Addendum No.: 2

York Correctional Institution Central Plant and Piping Distribution

BI – JA – 465

The following clarifications are applicable to drawings and specifications for the project referenced above.

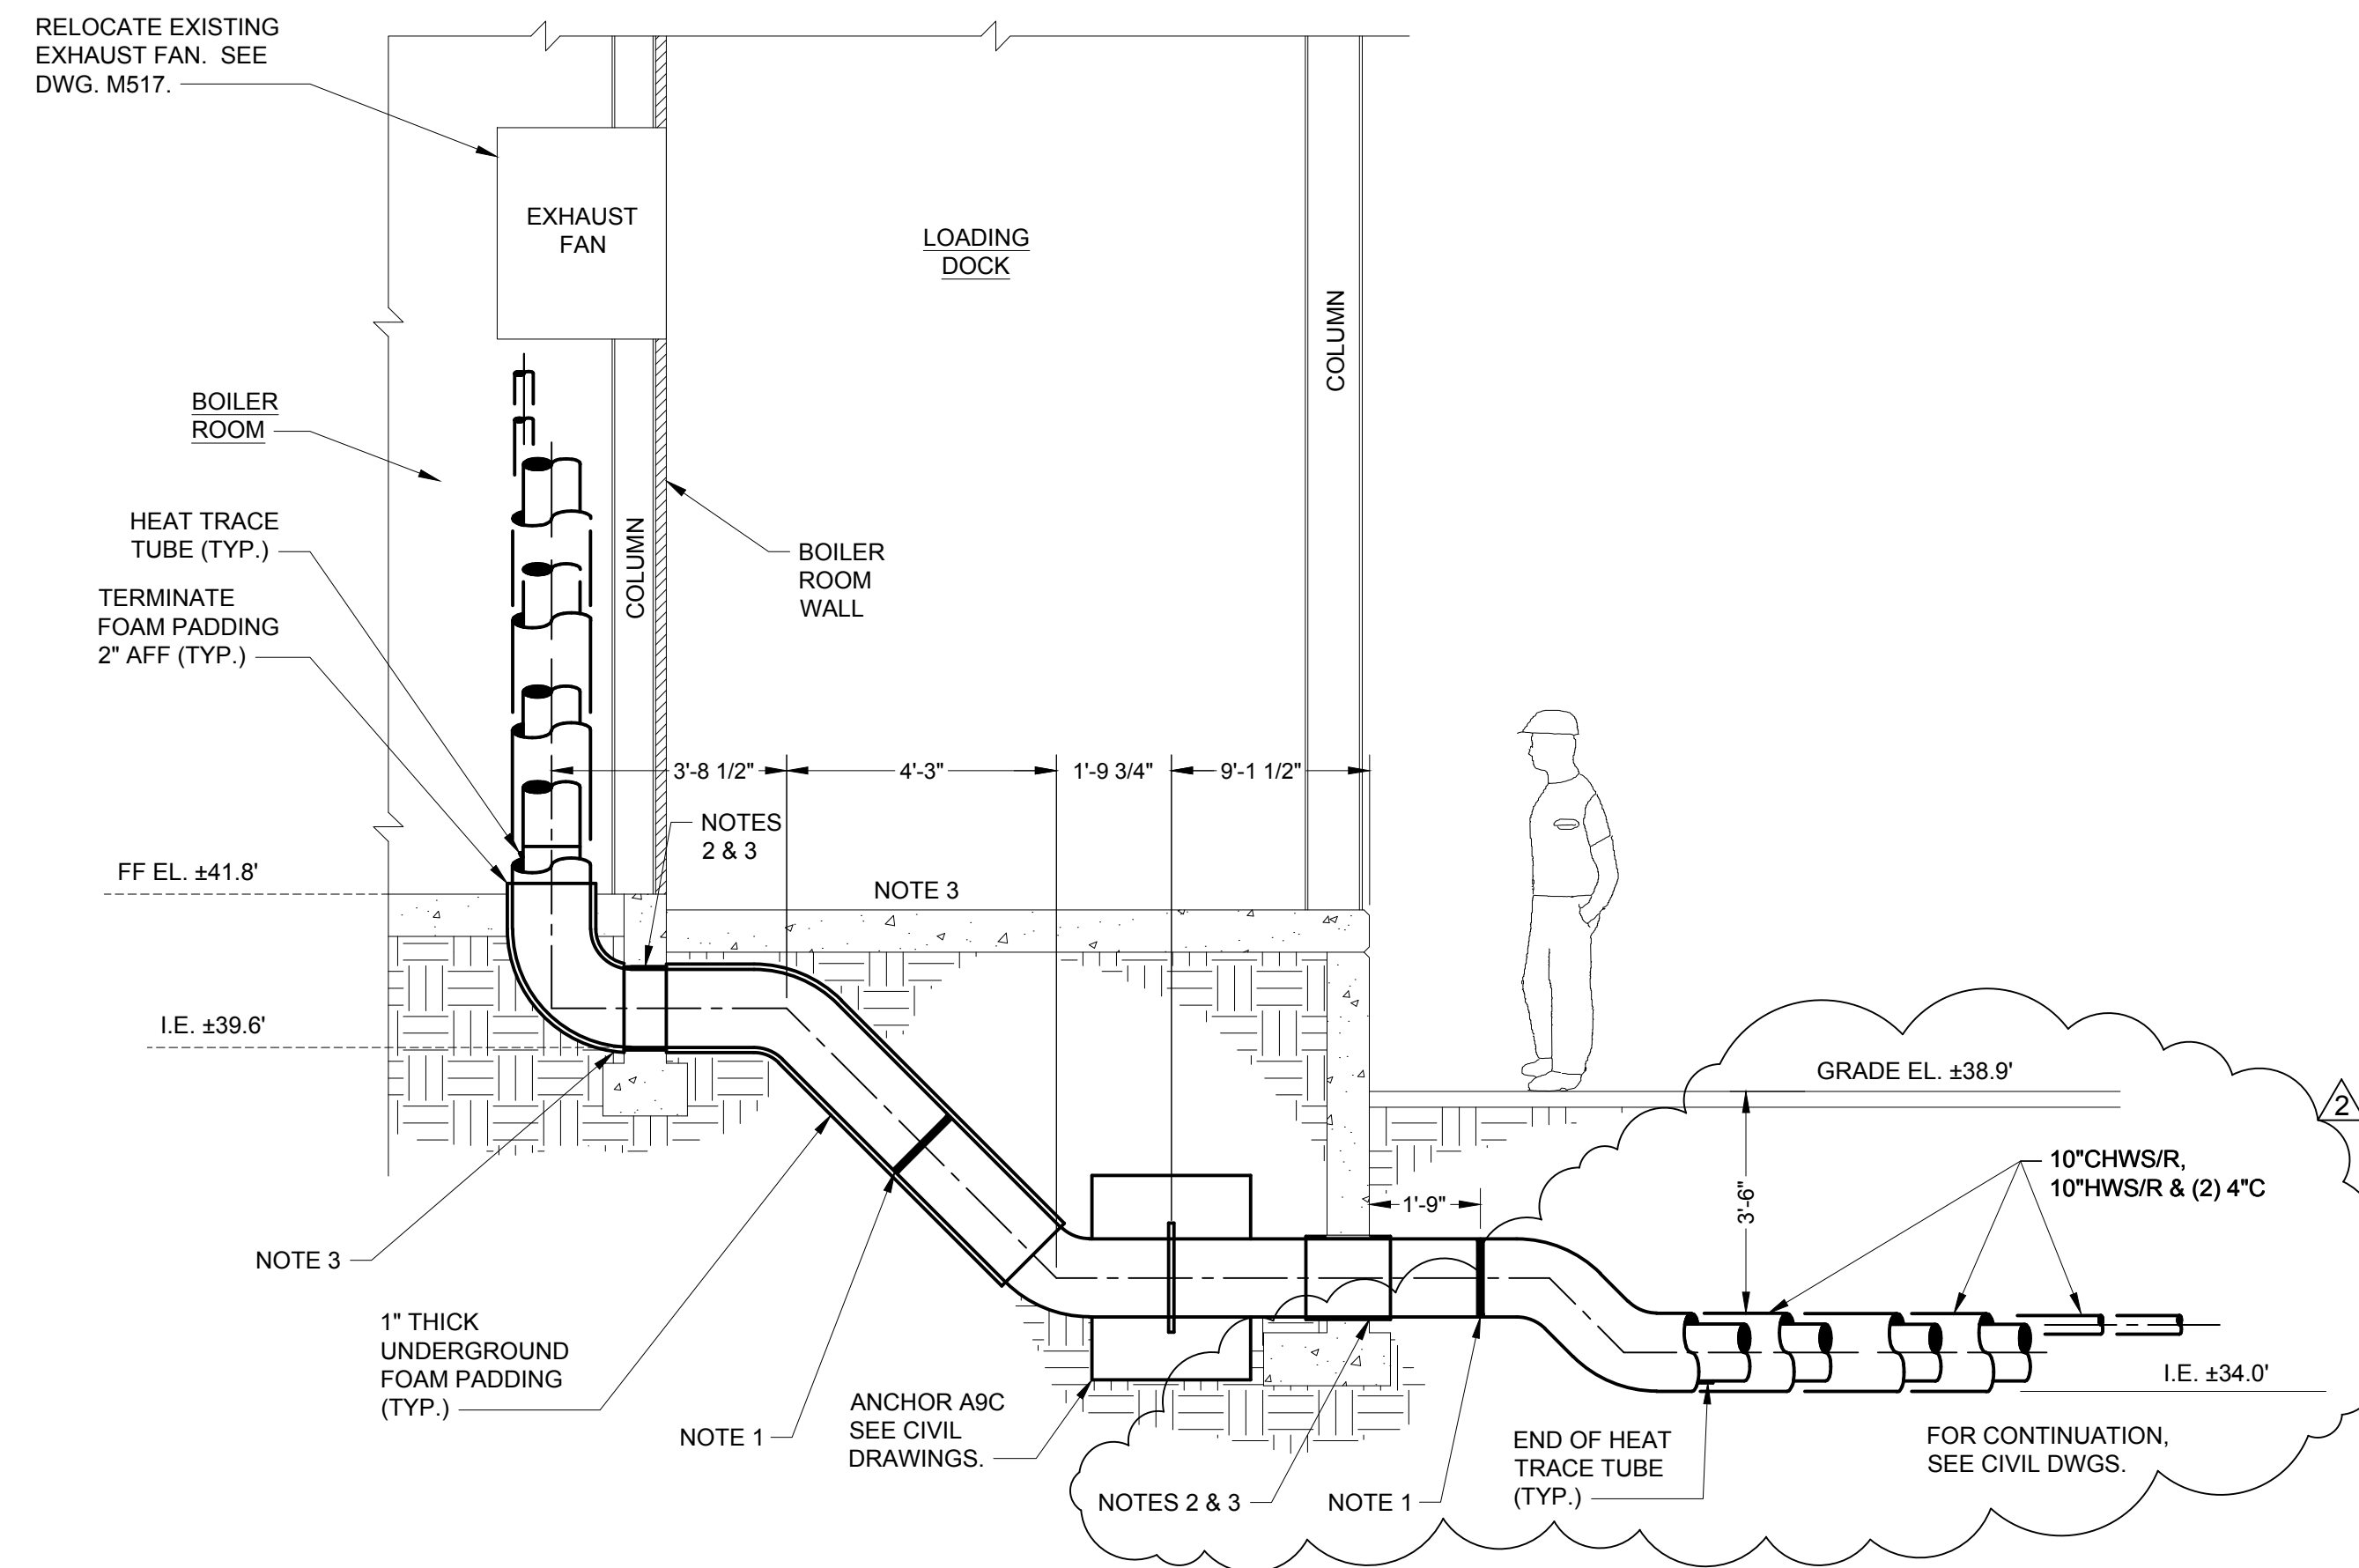
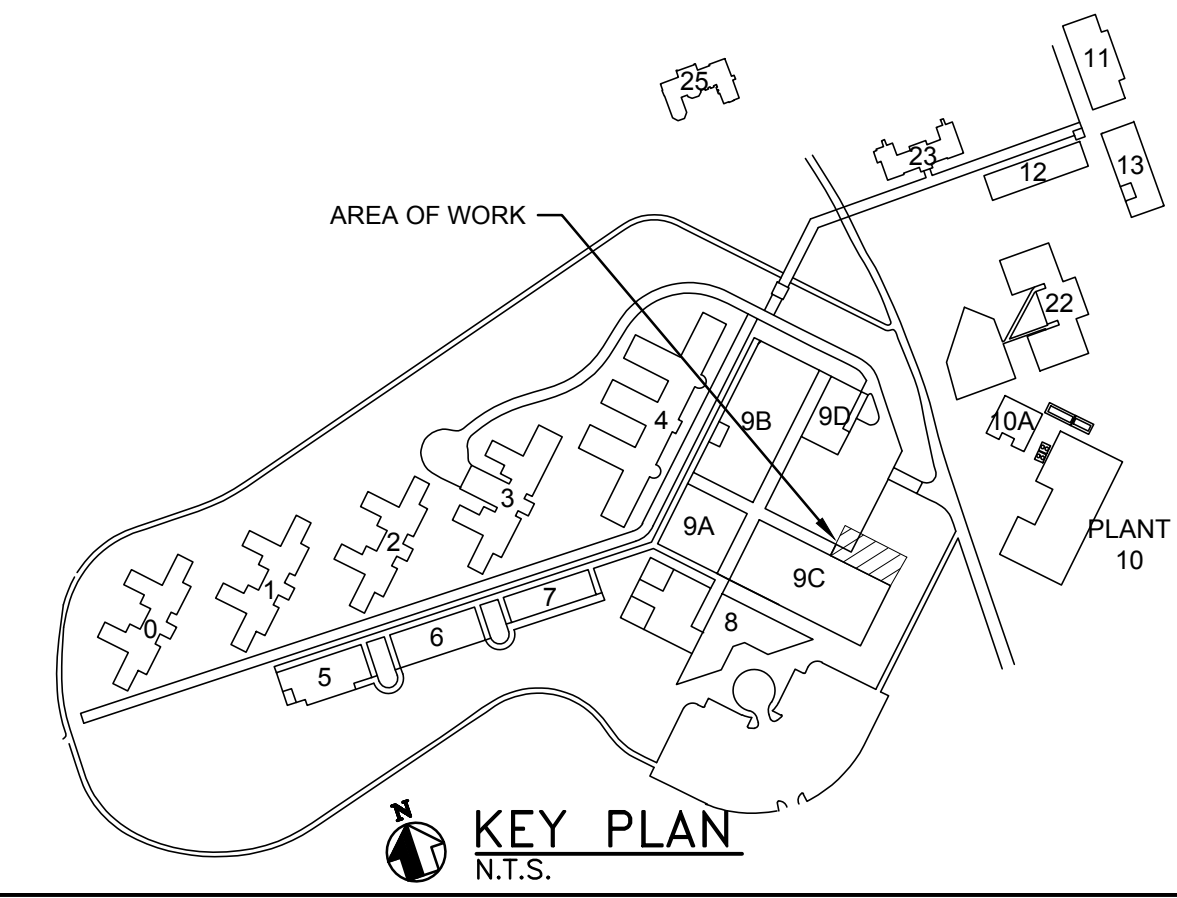
Drawing M518 Building 9C Boiler Room Installation Section

**UPDATED** section to show second underground piping offset.

- ***Q1: (23A/26A) On Addendum #1 Drawing M518, the grade elevation where the image of a person is 38.9' and the bottom of the trench is 35.34', which would make that approximately 3'-7" deep to the bottom of pipe. The 10" pipe with insulation is about 14" diameter, that would be approximately 28" of cover, and on Addendum #1 Drawing C502 Detail #6 indicates 42" min. cover. Do we need to Heat Trace the entire runs of all the HW & CHW S&R lines or do we lower the grade at the bottom of the trench? Please advise.***

A1: The intent is to provide heat tracing for limited lengths of underground piping where 42" cover is not available and not to provide heat tracing for entire runs of underground distribution piping. The segments of underground distribution which have less than 42" cover are generally short sections of piping which are near the new "doghouses" at the buildings and in the Building 9C loading dock area. The existing Fuel Oil piping from the Central Plant wall to the above ground Fuel Oil storage tank also gets heat traced per Drawing M209.
